# **RECORD OF DECISION**

**NAVAL WEAPONS INDUSTRIAL RESERVE PLANT  
BETHPAGE, NEW YORK  
OPERABLE UNIT 2 - GROUNDWATER  
NYS REGISTRY: 1-30-003B**

**JANUARY 2003  
APRIL 2003 (REVISION 1)**

**COMMENT RESPONSES FROM ENGINEERING FIELD ACTIVITY, NORTHEAST  
REGARDING  
FINAL NAVY RECORD OF DECISION FOR GROUNDWATER (JANUARY 2003)  
NAVAL WEAPONS INDUSTRIAL RESERVE PLANT (NWIRP) BETHPAGE, NEW YORK**

CONTRACT NUMBER		OWNER NUMBER	
APPROVED BY		DATE	
APPROVED BY		DATE	
DRAWING NO. FIGURE 2			REV 0

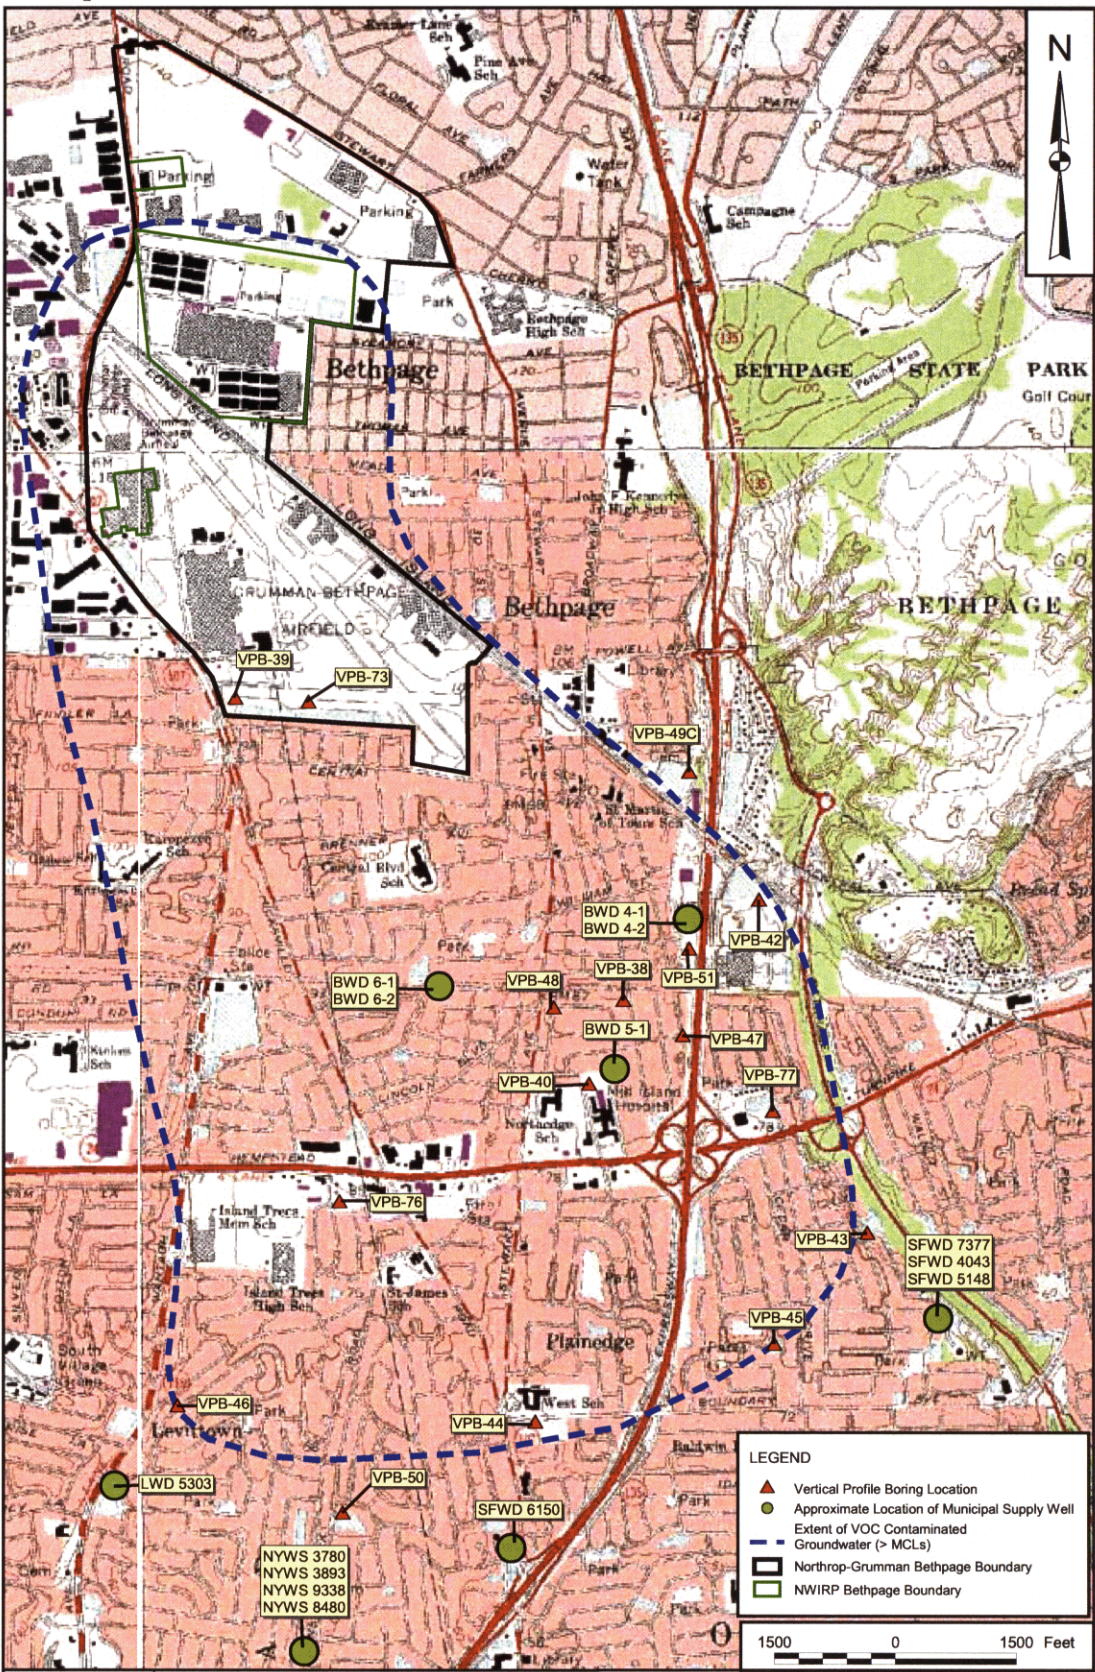
9. Pages 5 and 6 of the ROD identify the former disposal areas as "Area 1," "Area 2" and "Area 3." These areas are described as "Site 1," "Site 2" and "Site 3" on Figure 2 and on page 11. Identification of the area should be consistent.

**RESPONSE TO 9:** References made to the former disposal areas will be revised on pages 5 and 6 to match the term "Site" used on Figure 2.

CONTRACT NUMBER N4037	OWNER NUMBER
APPROVED BY	DATE
APPROVED BY	DATE
DRAWING NO. FIGURE 5	REV 0

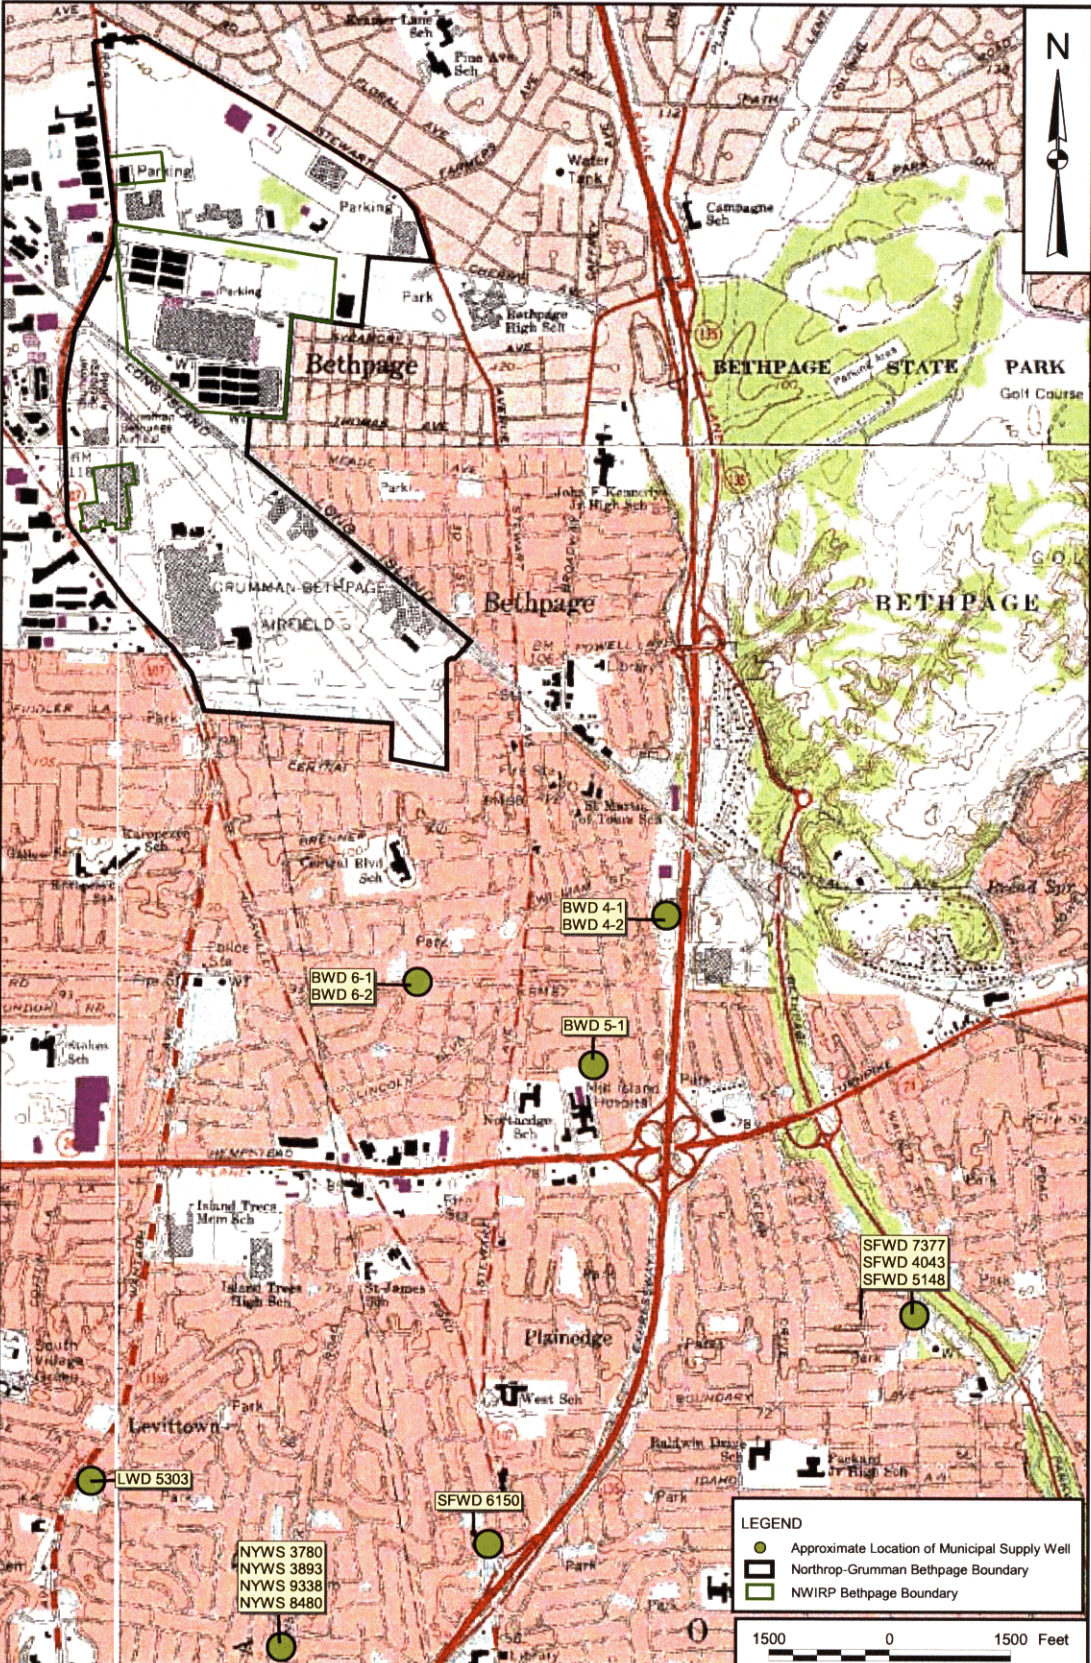
- Figures 3 and 5 - Please correct the location of the wells at Plant site 1. Wells N-4043, N-5148 and N-7377 are on the same Plant site (1) and well N-4042 no longer exists.
